Equipment Technical Bulletin

Probe Color Change/New Thread Leads

Figure 1. Old blue probe #018079 with threads all the way to the bottom.

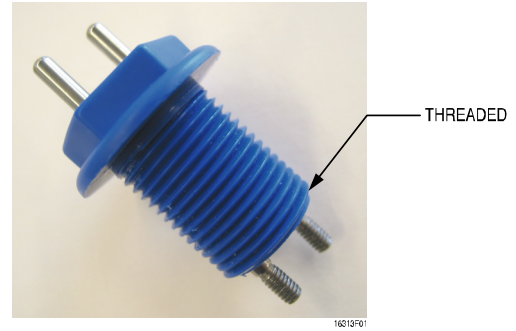
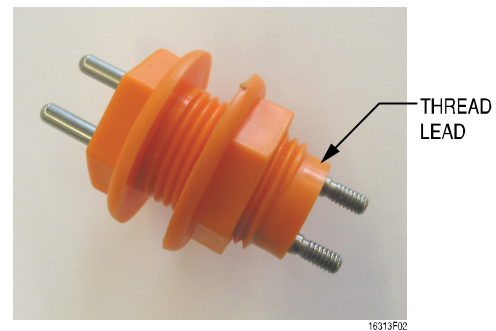
Beta's standard blue probe 018079 (099466 in kits) is a little difficult to assemble.

1. A thread lead has been added, so the nut matches up with the probe body threads easier, reducing crossthreading.
2. The nut has been made slightly larger, so it screws on easier.
3. The probe color has been changed to orange to differentiate it from the old probe. The item number has not changed.
